To:	Matt Corsi – Urban Evolution
From:	Matthew W. Smith, PE and Aaron Hartvigsen, PE
Date:	January 5, 2016
File:	12406-015-00
Subject:	Issaquah Senior – Steep Slope Considerations

The purpose of this memorandum is to provide discussion of code requirements and available information regarding steep slopes mapped along the western property line.

EXISTING SLOPE ANALYSIS

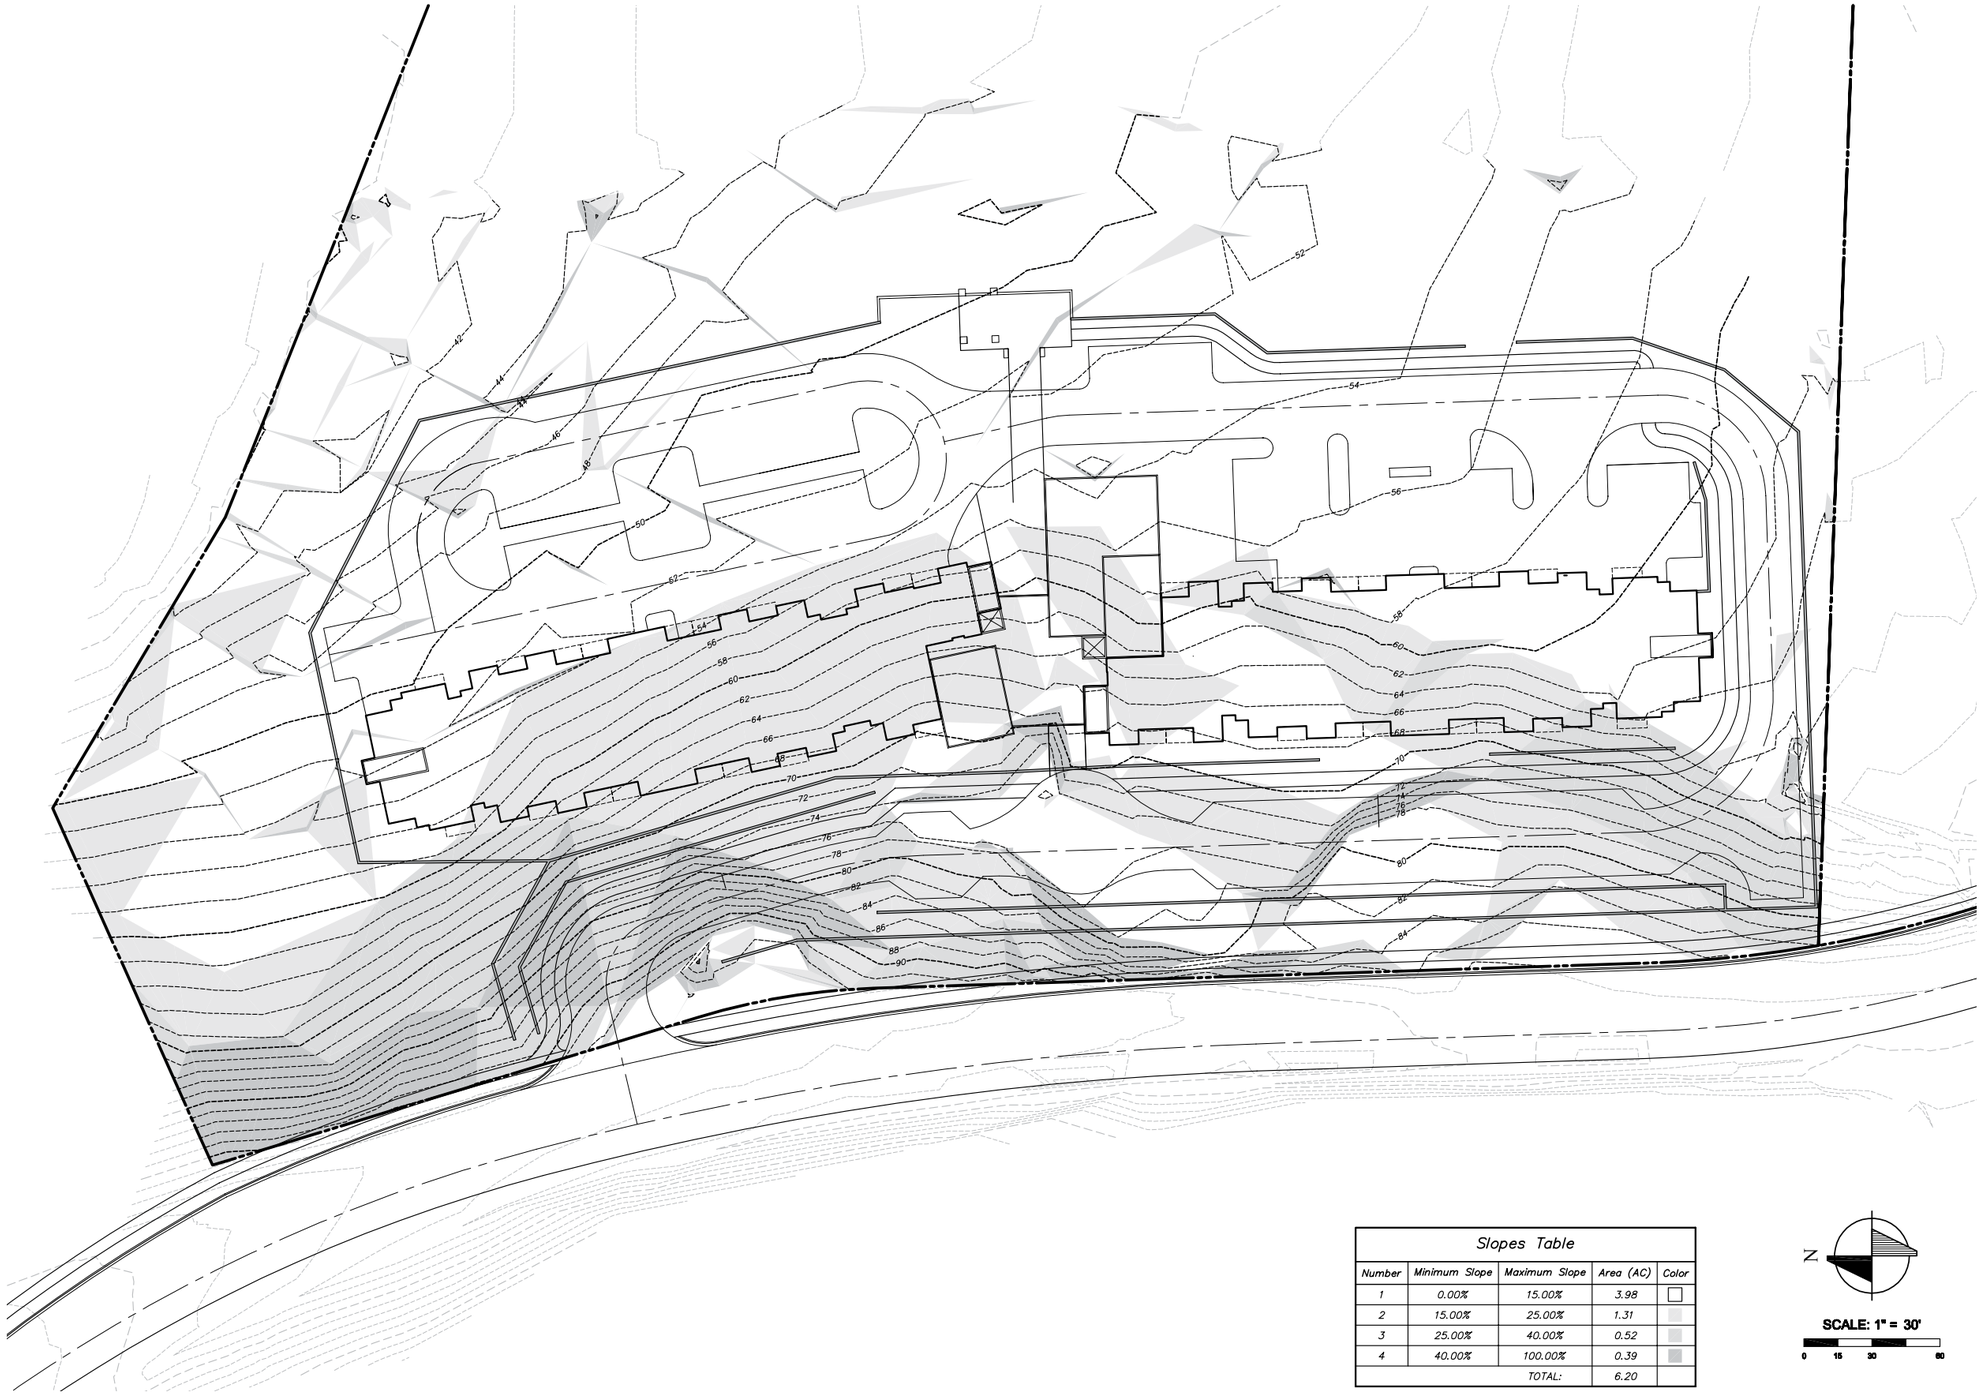
We reviewed the site topography based on the Existing Slope Analysis Figure provided by VIA Architecture and Site Sections Provided by Triad (attached). The areas shaded the darkest gray are 40 percent or steeper. The area that meets steep slope requirements per the above referenced code is located at the northwest portion of the property. The elevation changes is approximately 22 to 24 feet through the steep portion of the slope immediately below Newport Way. The contours are at a consistent spacing until the catch point, which is typically near Elevation 70 feet. The slope of what appears to be the natural grade is not as steep (15 percent to 25 percent) before transitioning to a much shallower slope (less than 15 percent) across the eastern half of the site. Cross Section A depicts the portion of the slope that is steeper than 40 percent and in excess of 20 feet in height. The other sections, B, C and D, depict that the portions of the slope that are steeper than 40 percent are shorter than 20 feet tall.

SECTION A

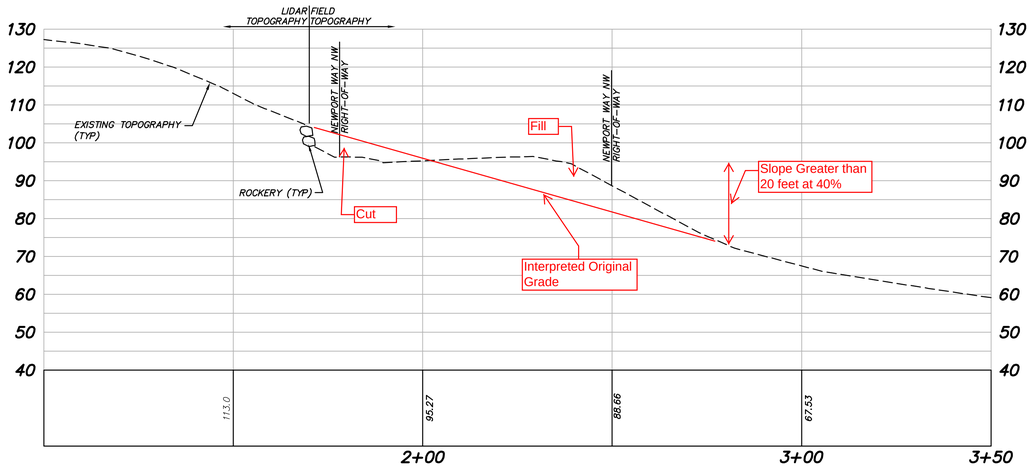
It is our opinion that the steep slopes at the site with less than 20 feet in elevation change (Sections B, C and D) meet the requirements of Limited Exemption 1. It is our opinion that slopes with greater than 20 feet in elevation change (Section A) meet the requirements of Limited Exemption 2, based on our review of site topography as well as existing and historical information. All earthwork and retaining structures should be designed and built in accordance with our recommendations.
